ADDENDUM NO. 2

PROJECT: UNT Kerr Hall Dining Renovation
HE0569.2302.01

DATE: 05/23/2025

ITEM DETAILA101 - FLOOR PLAN (KITCHEN & DINING)

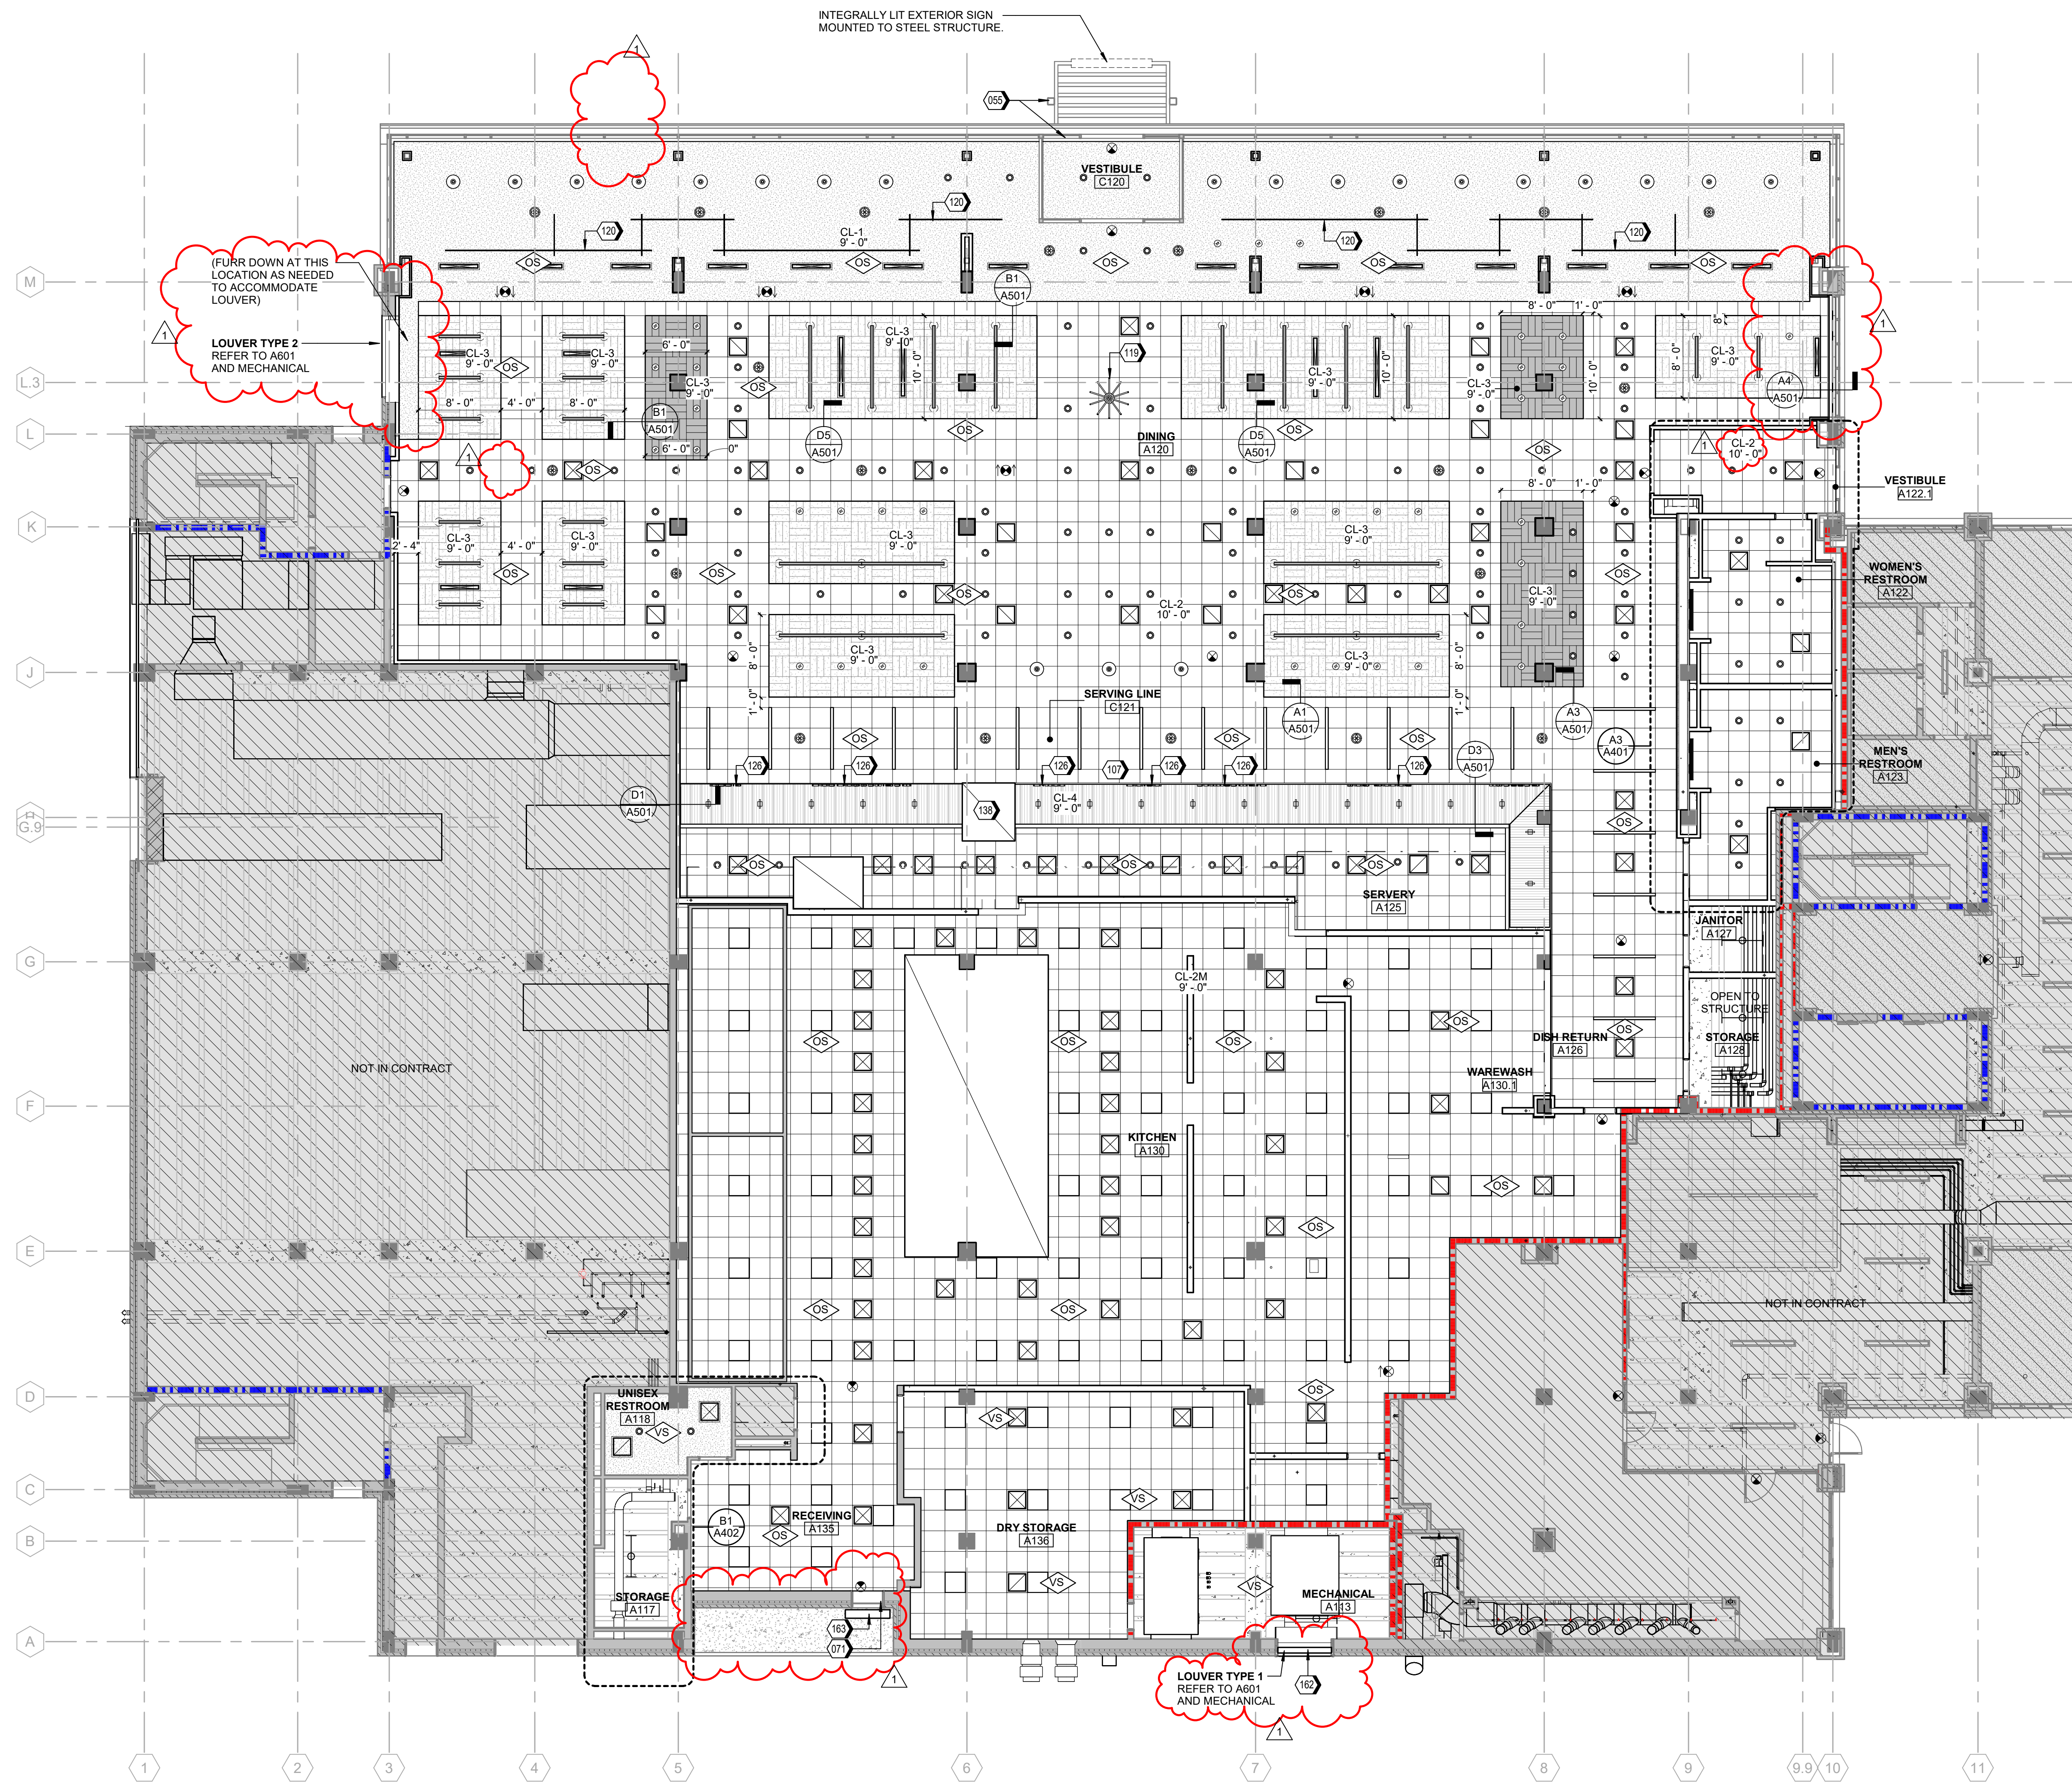
SCOPE AT LOADING DOCK DOORS CLARIFIED. KEYNOTE TAGS 148, 147, 159, AND 156 REVISED. FURRING WALL (F3) ADDED BY GLAZING ADJACENT TO VESTIBULE A122.1, INCLUDING A NEW DETAIL AND CEILING CONDITION IN THIS AREA. KNOX BOX AND FACP LOCATION ADDED TO PLAN.

NEW WALL TO EXISTING WALL TRANSITION A6
1 1/2" = 1'-0"

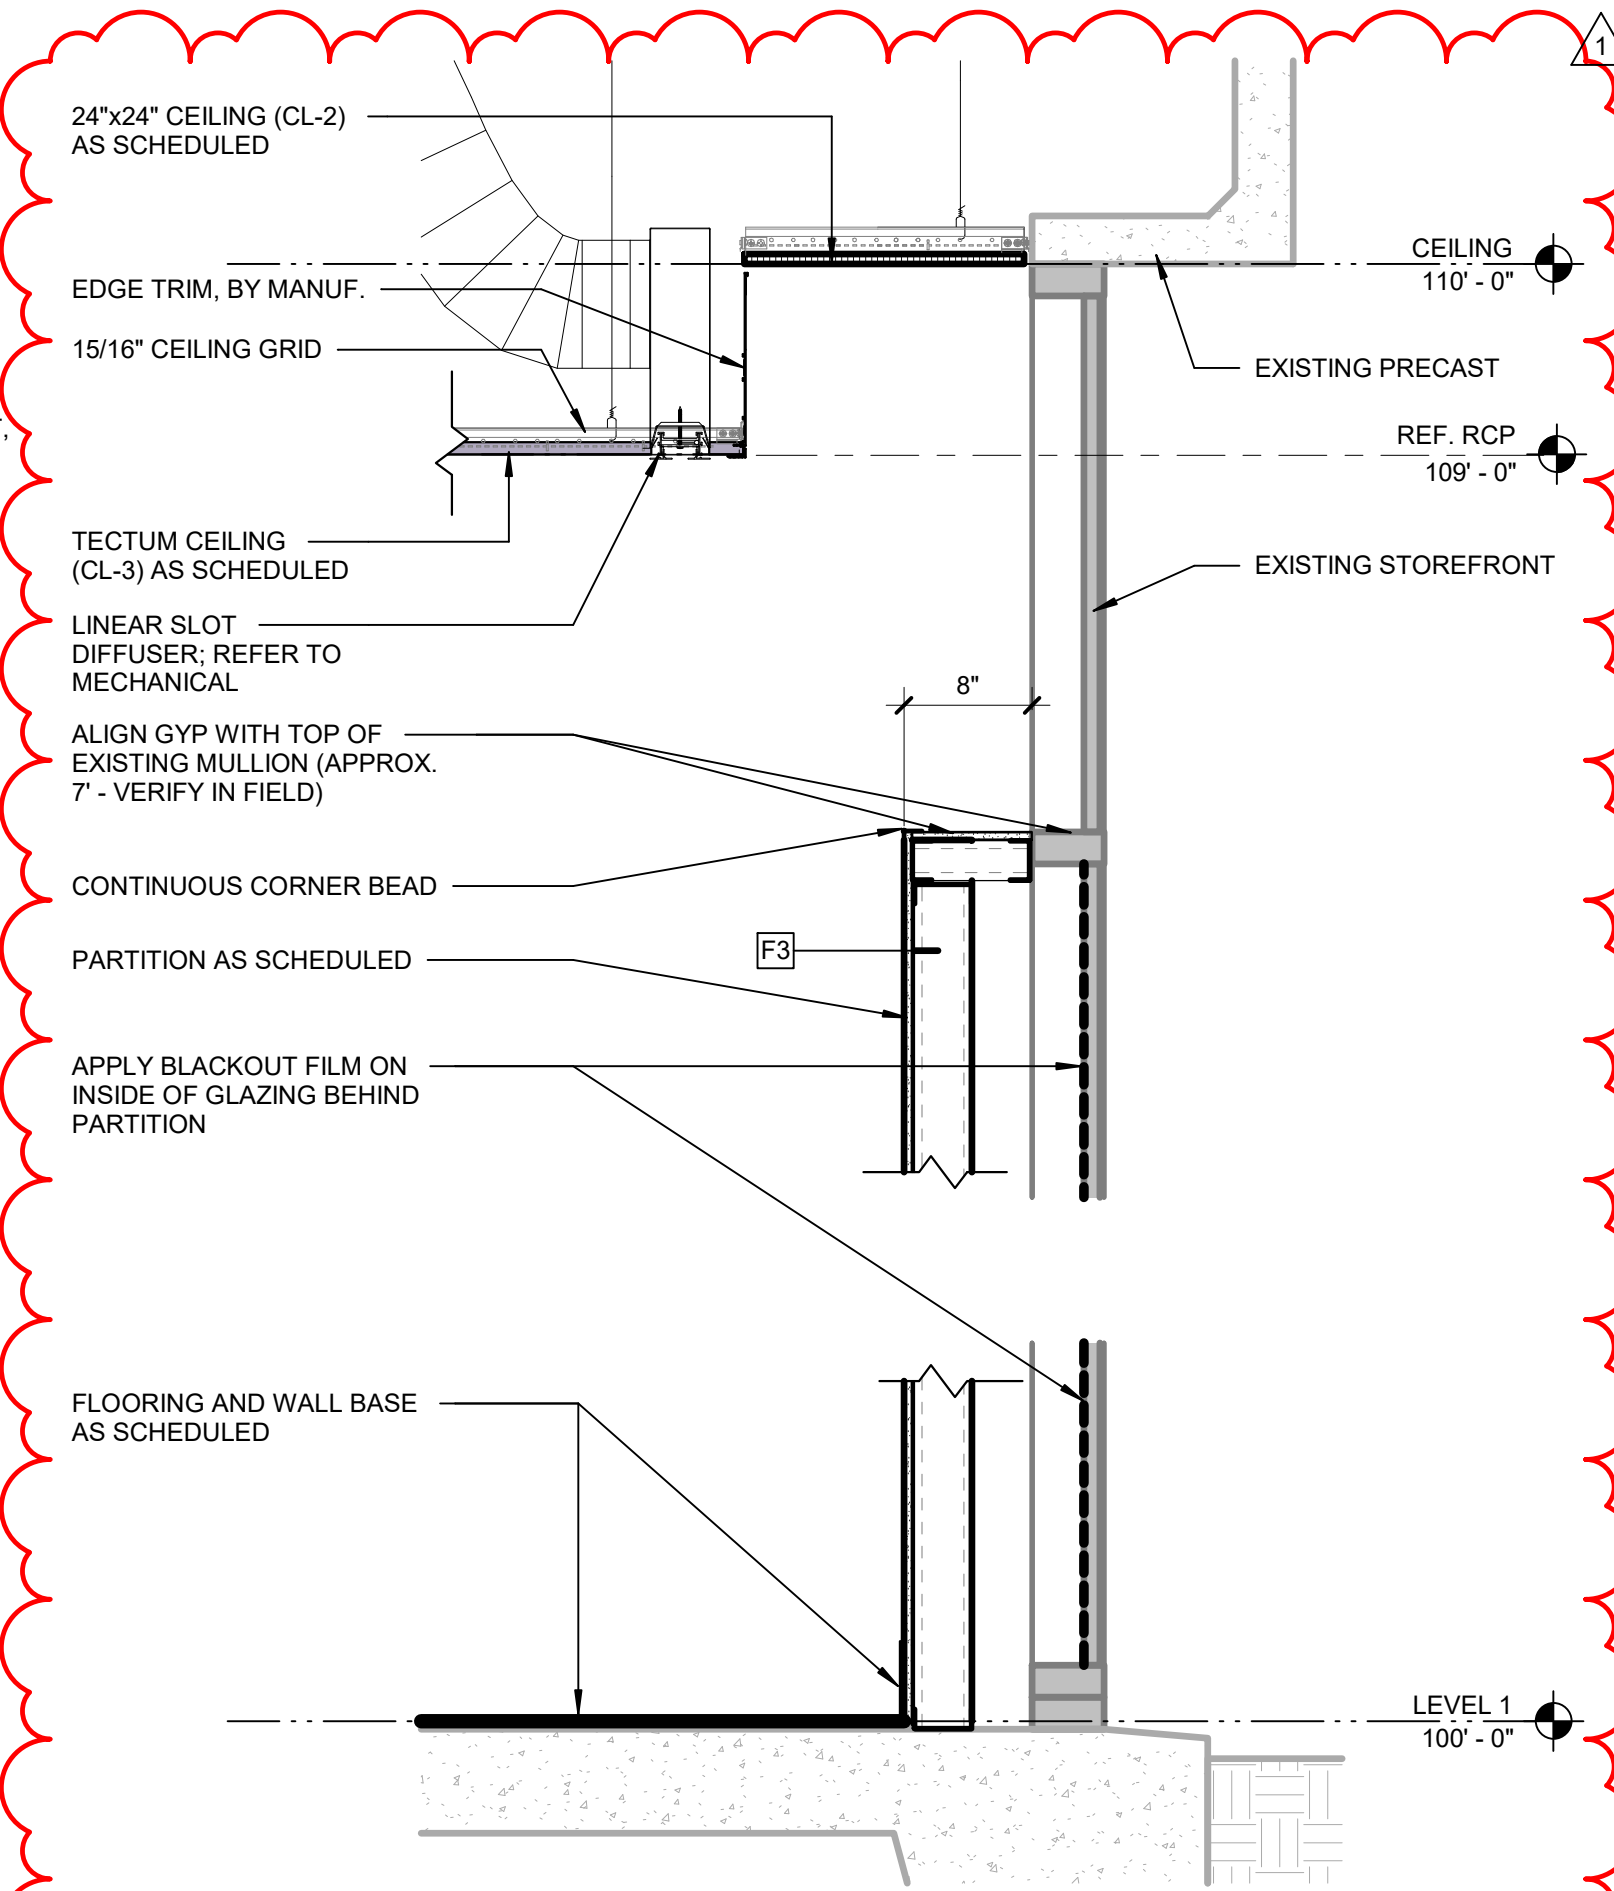
DETAILS A6 AND C6/A601 ADDED. LOUVER TYPES 1 AND 2 DEFINED, DETAILED, AND DIMENSIONED.

SECTION DETAIL AT EXISTING SIDE GLAZING A4
1" = 1'-0"

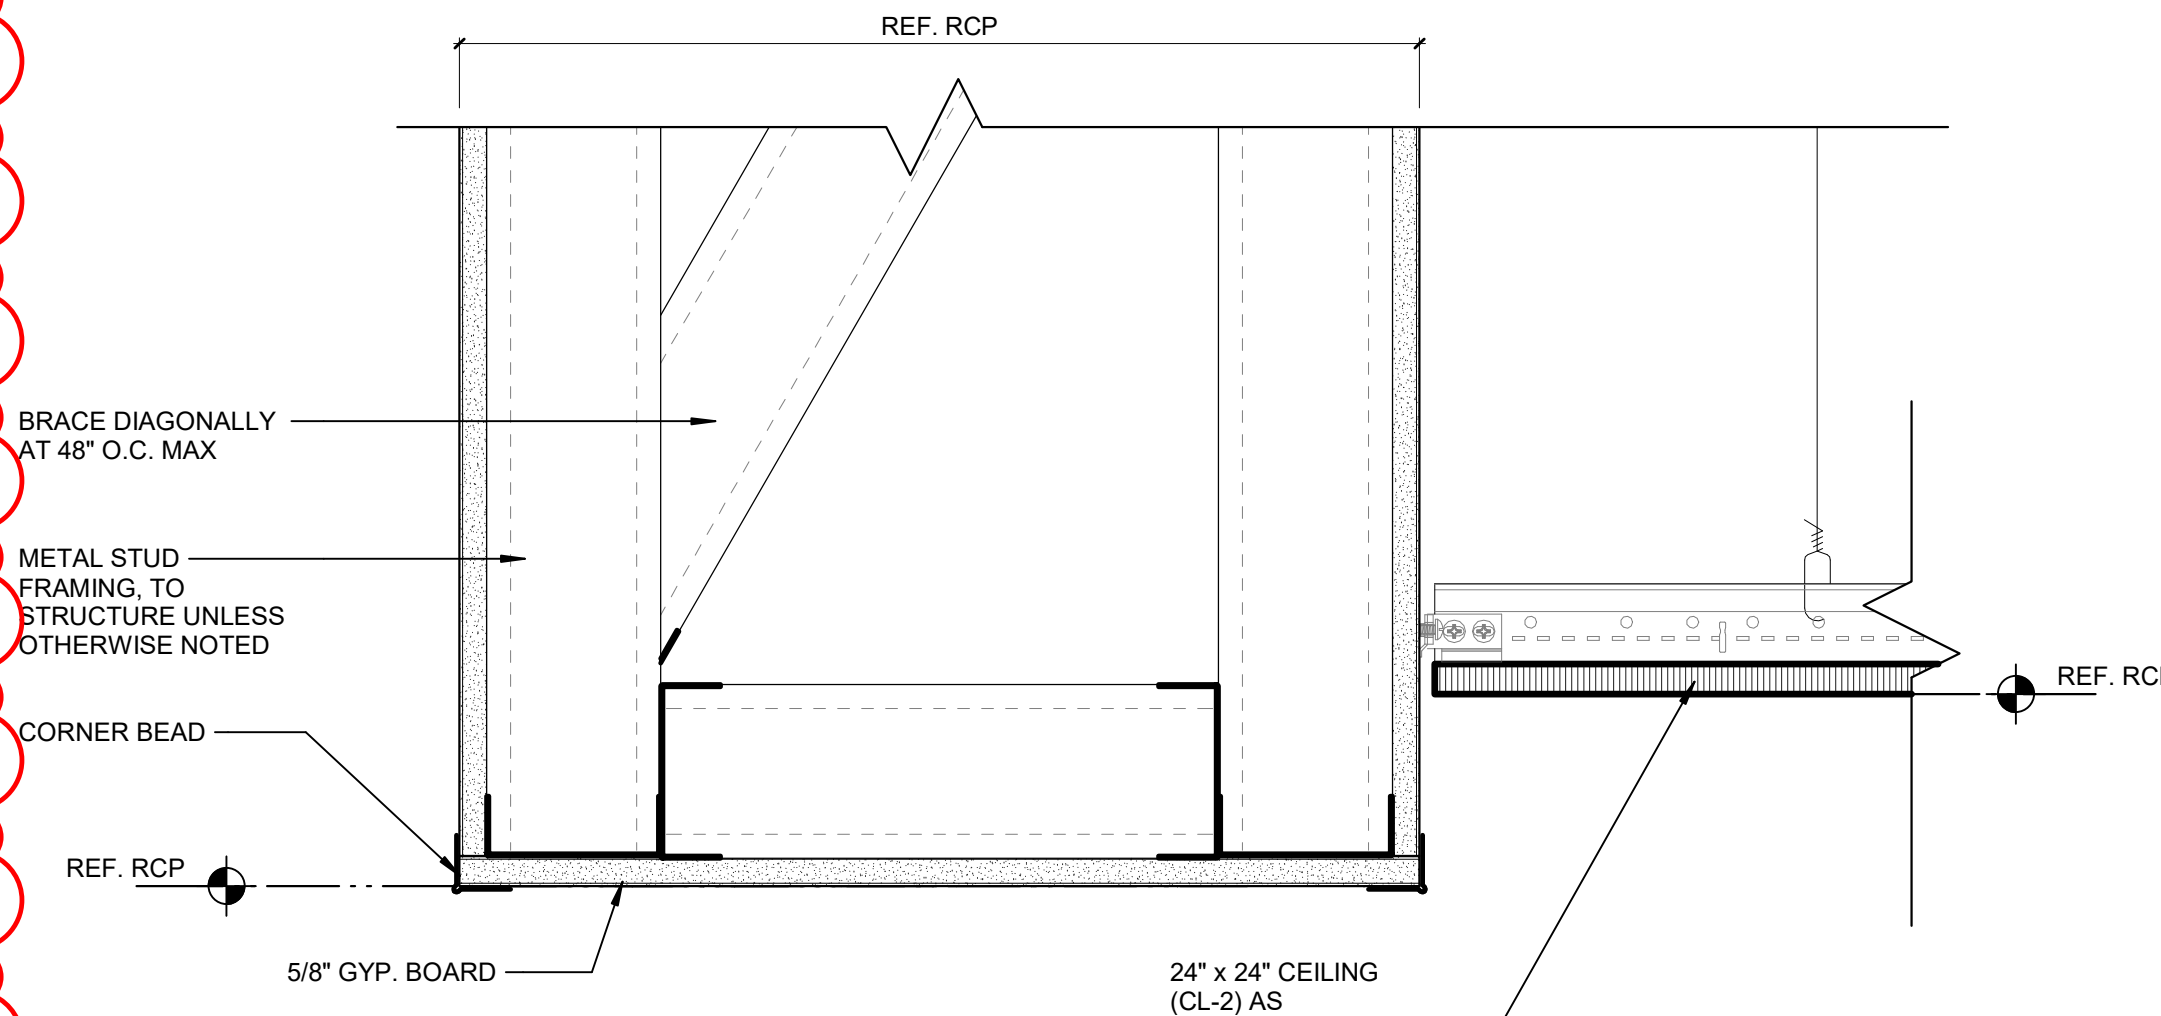
A4/A501 CREATED TO SHOW NEW CONDITION AT EXTERIOR GLAZING. B5/A501 REMOVED.
